STAFF REPORT

CITY OF COLUMBUS PLAN COMMISSION (November 13, 2013 Meeting)

Docket No. / Project Title: DP-13-26 (Columbus East High School)
Staff: Melissa Begley
Applicant: Bartholomew Consolidated School Corporation
Property Size: 39.99 Acres
Current Zoning: P (Public/Semi-Public Facilities)
Location: 230 South Marr Road, in the City of Columbus

The applicant has indicated that the proposed site development plan major modification is for the purpose of constructing an 8,320 square foot addition to the north side of the building.

DRAWING TITLE:
ENTIRE SITE
PLAN

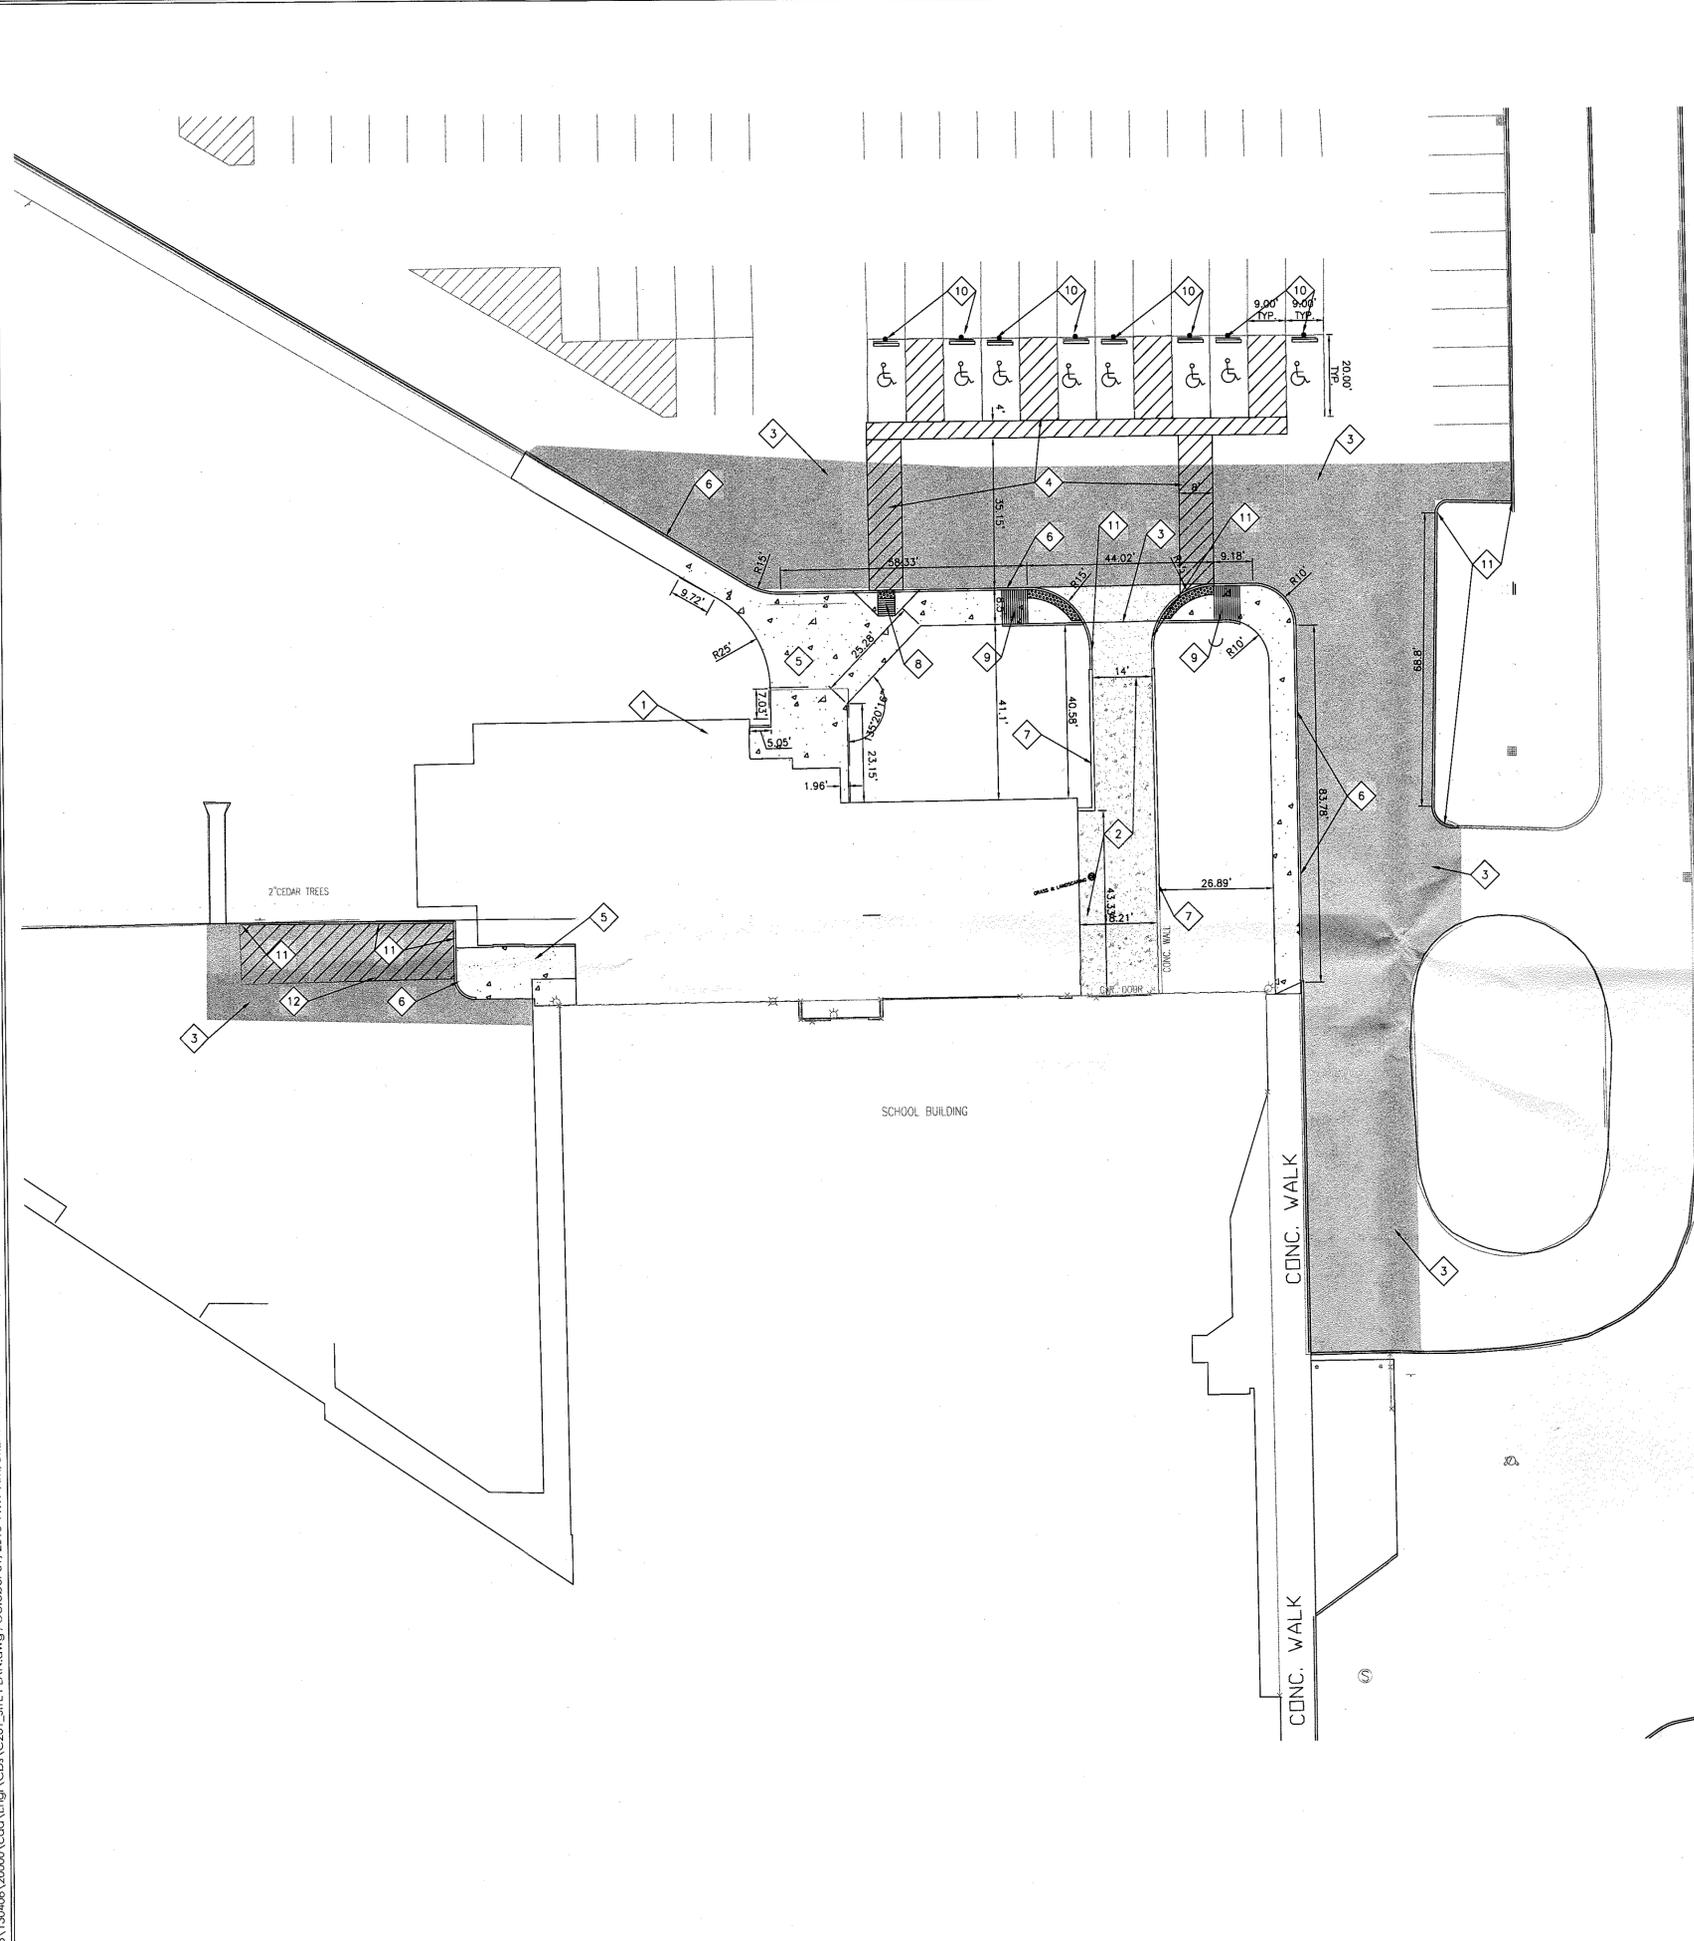
Preliminary Staff Findings: The site currently has provided 724 spaces, which is 776 fewer spaces than required. The applicant has indicated that the gymnasium is only maximized a couple times of year, such as graduation ceremonies. Adequate off street parking is provided for the typical school day. *This criterion has been met.*

1. The parking space standard for a school (grades 9-12) is based off of the seating capacity of the largest assembly area. One parking space is required for every 3 persons. The gymnasium has a capacity of 4,500 persons, and would require a total of 1,500 parking spaces. The site currently has 741 parking spaces, 759 fewer spaces than required. The applicant has indicated that the gymnasium is only maximized a couple times of year, such as during graduation ceremonies. With the construction of the new addition, 17 parking spaces will be removed for a total of 724 parking spaces on-site. 23 handicap accessible parking spaces are provided on site, 15 are required.

DRAWING TITLE:
LANDSCAPE PLAN

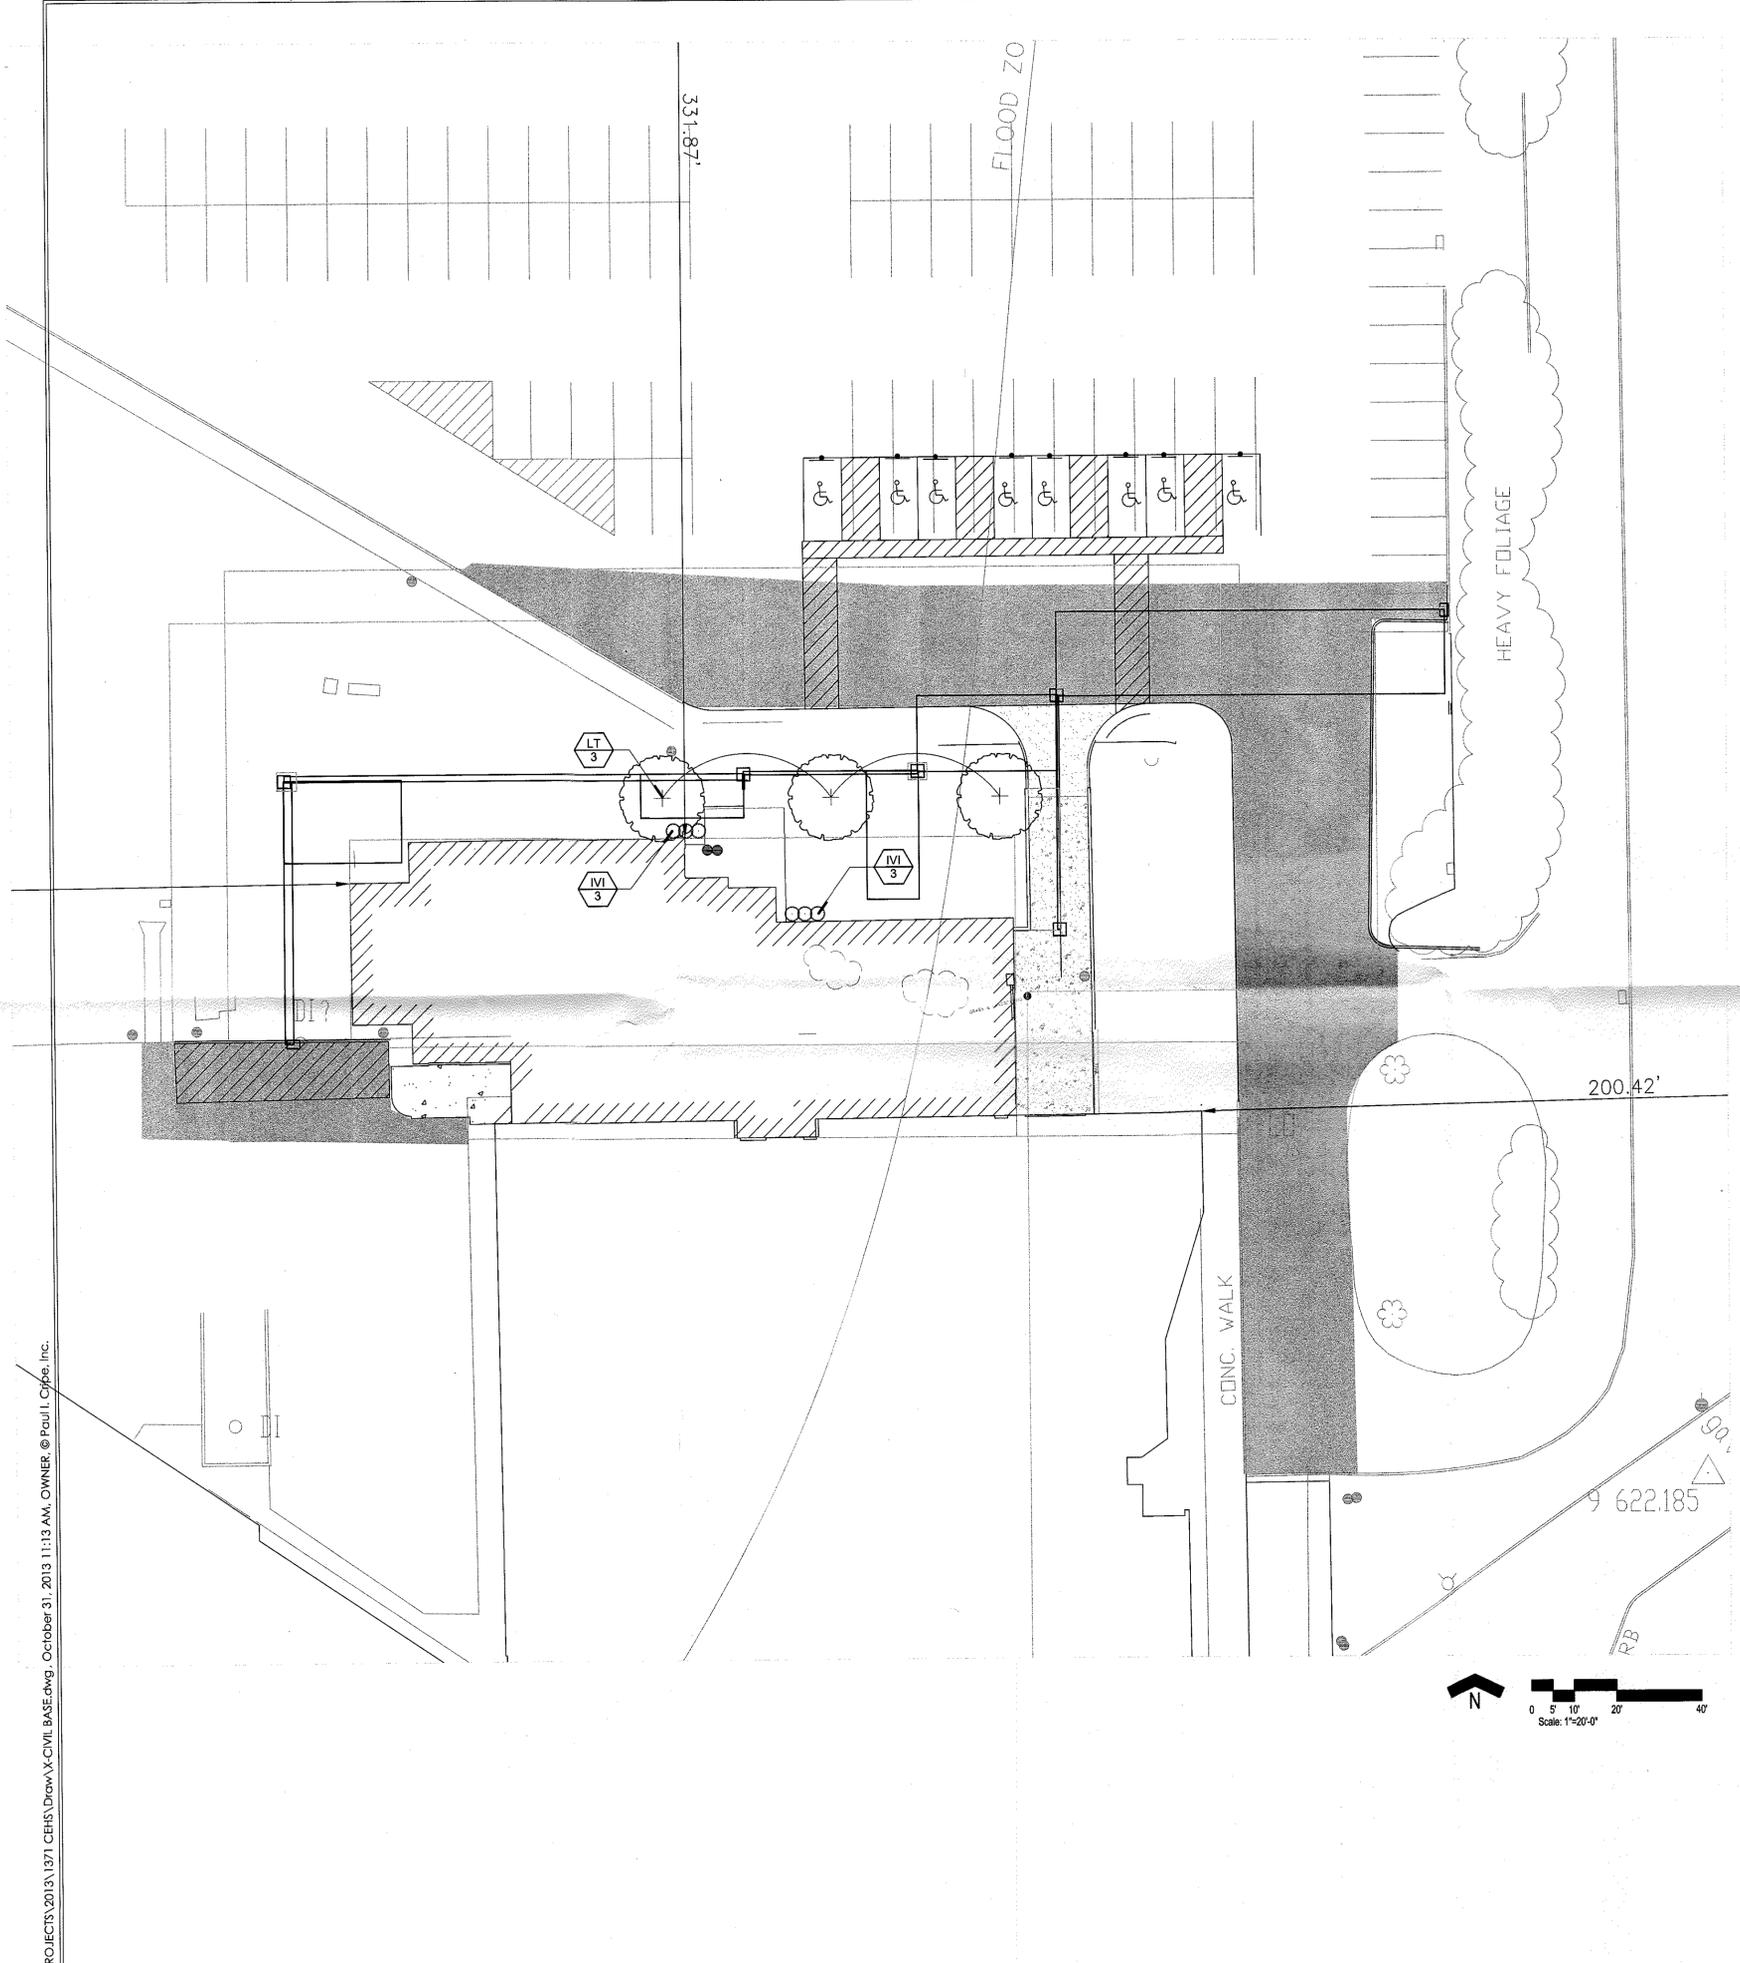
3. Lot Interior landscaping (Area #4) is required around the new addition. 78 points of landscaping is required and the applicant is proposing 3 shade trees and 6 shrubs for a total of 120 points.
